client	Gold Park Homes
project	Mclaughlin and Mayfield
model	SD-7 Brampton
project #	13098
scale	3/16" = 1'0"
lot(s)

PART. BASEMENT FL. ELEV. 'D' - LOT 63R

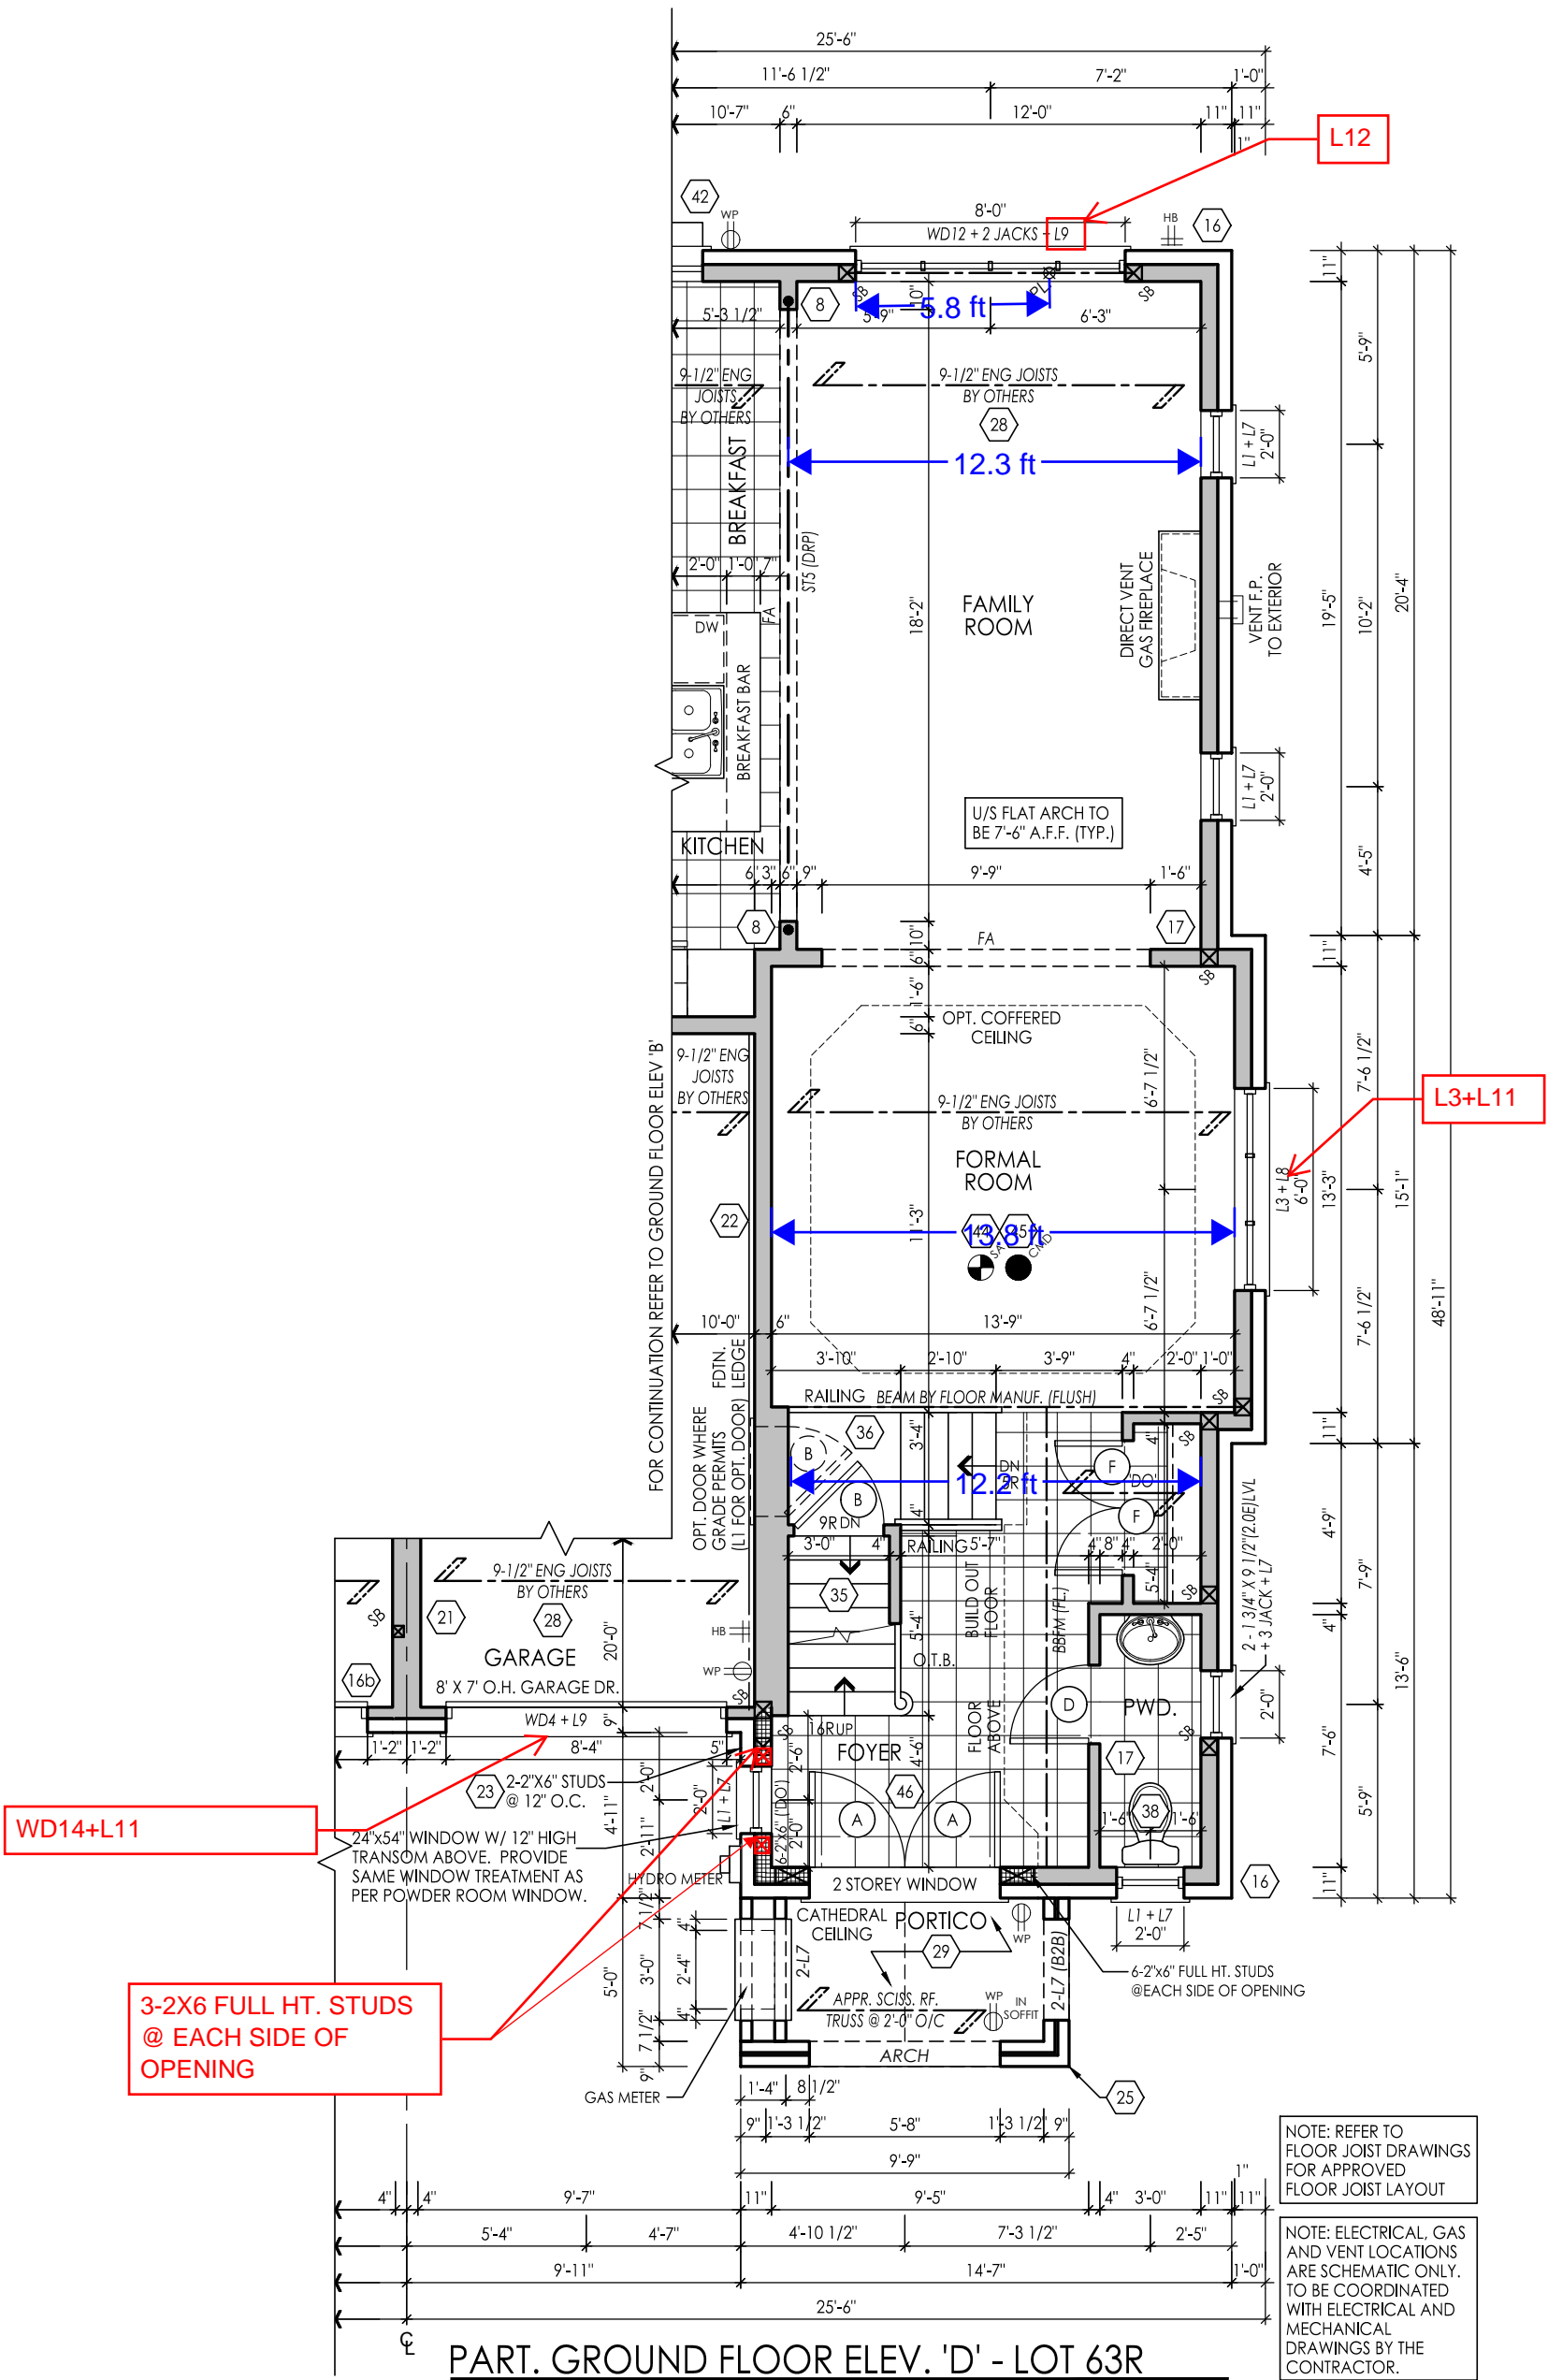
REPLACE SECTION SK-1 WITH THE FOLLOWING TEXT (TYP.):
2-20M LONG. CONT. BAR @ TOP OF WALL, 1 EACH FACE, EXT. 2'-0" BEYOND OPENING, 2" CLR. COVER OUTSIDE FACE, 3/4" CLR. COVER INSIDE FACE

2-20M VERT. REBAR, FULL HEIGHT, 3/4" CLR. COVER INSIDE FACE
